# **Some Comments on Assembly and Performance of pre-series RE2/2 chambers**

With input and comments from colleagues in the ISR lab and PH-CMM

The 3 Chambers were received at CERN on the 2nd June 2005.

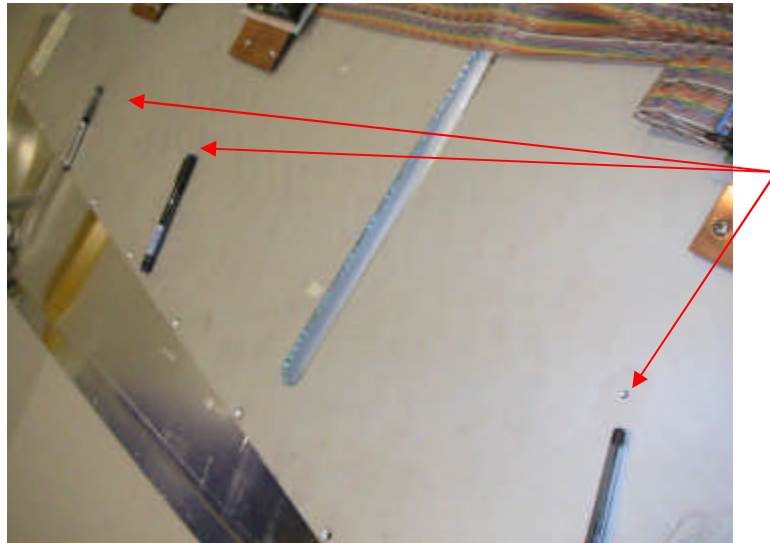
The shield cover had been intended to be mounted on the 6 x M5 threaded inserts indicated in the photo below. The use of a full span shield cover has some advantages , such as immediate full access, but will inevitably increase the occupation in 'Z' due o the flexibility of itself. Primarily ,however, the access to the electronics/chamber of the on yoke chambers requires the 2 adjacent chambers to be removed beforehand. This mistake has been made by the CSCs , we should not limit our access, especially since the decision to have the CSCs on one yoke and the RPCs on the opposite was made in part for this reason

Note the 3 pens indicating the positions of the mounting inserts.

The shield cover was designed to be attached at six points along 'R' each side of the FEB's. Taking the cover to the outside edges increase the occupation in 'Z'.The cover is 25 mm deep and should be decreased to ~20mm as is achieved in RE1/2. & 3. The total chamber thickness is between 56.4 and 55.4mm.

- Service ( Pipe) cross-over

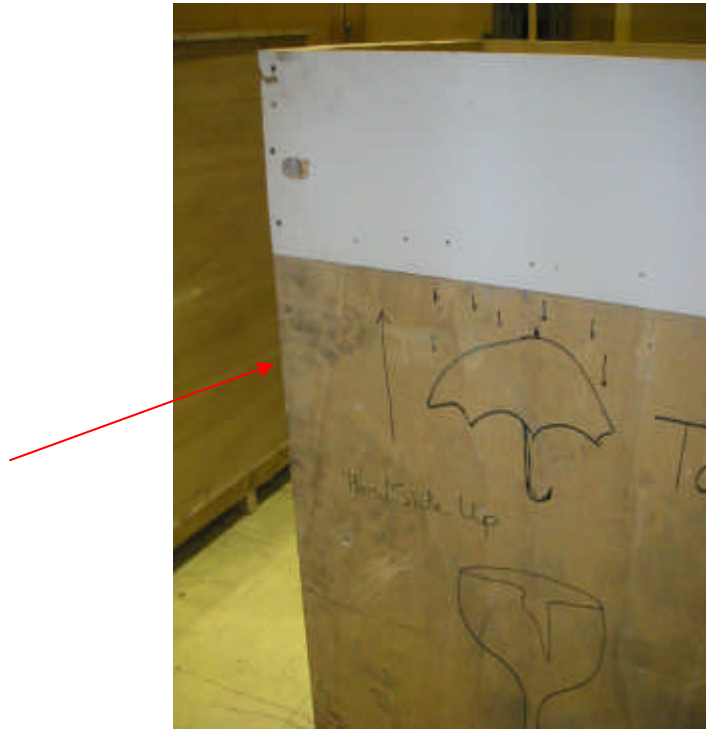
Crossing of services introduces unnecessary increase in, the thickness. Here the gas pipes are crossed and both cross with the cooling pipe.
